Access Compliance Report Public Rights-of-Way (Curb Ramps)

Main Street: ANTONIO_PKWY Cross Street: AVENDALE_BLVD Location: SE

ADA ID: RPRK211116120943 Ramp Type: Type 4 - Parallel Initial Pass/Fail: Pass Overall Compliance: No Severity Score: 20

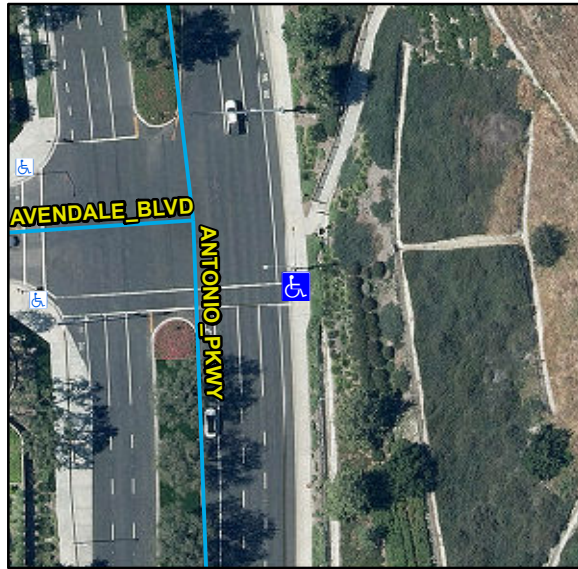
Compliance	Description	Data	Compliance	Description	Data
N/A	Ramp Length LT (in)	123	N/A	Ramp Length RT (in)	150
Yes	Ramp Width LT (in)	93	Yes	Ramp Width RT (in)	93
Yes	Ramp Run Slope LT (%)	6.7	Yes	Ramp Run Slope RT (%)	5.1
Yes	Ramp Cross Slope LT (%)	1.9	Yes	Ramp Cross Slope RT (%)	0.5
N/A	Landing Present	No	No	DWS Provided	No
N/A	Landing Length (in)	N/A	N/A	DWS Contrast	N/A
No	Landing Width (in)	N/A	N/A	DWS Length (in)	N/A
No	Landing Run Slope (%)	N/A	N/A	DWS Full Width	N/A
No	Landing Cross Slope (%)	N/A		DWS Offset Type	N/A
N/A	Landing Movement Obstructed?	No	N/A	DWS Offset Left (in)	N/A
	Landing Movement Type	Curb	N/A	DWS Offset Right (in)	N/A
N/A	Landing Shared	N/A			
N/A	Clear Space	N/A			
N/A	Clear Space To Crosswalk (in)	N/A			
N/A	Marked Crosswalk 1	Yes	N/A	Marked Crosswalk 2	N/A
	Crossing 1 Direction	W		Crossing 2 Direction	N/A
	Marked Crosswalk 1 Width (in)	144		Marked Crosswalk 2 Width (in)	N/A

Yes	Ramp Inside Crosswalk 1	Yes	N/A	Ramp Inside Crosswalk 2	N/A
	Crossing 1 Slope (%)	3		Crossing 2 Slope (%)	N/A
	Crossing 1 Cross Slope (%)	1.2		Crossing 2 Cross Slope (%)	N/A
Yes	Gutter Ponding	No	No	Curb Slope	9.8
Yes	Gutter Lip Height (in)	0		Road Run Slope (%)	N/A
Yes	Gutter Run Slope (%)	5		Road Cross Slope (%)	N/A
Yes	Gutter Cross Slope (%)	1.9	No	Perpendicular Joint Present	No
Yes	Overall Surface Condition	Acceptable			
	Cross Gutter Present?	No		Spandrel Present?	No
	Replace Cross Gutter?	N/A		Replace Spandrel?	N/A

Remove & Replace Entire Ramp.
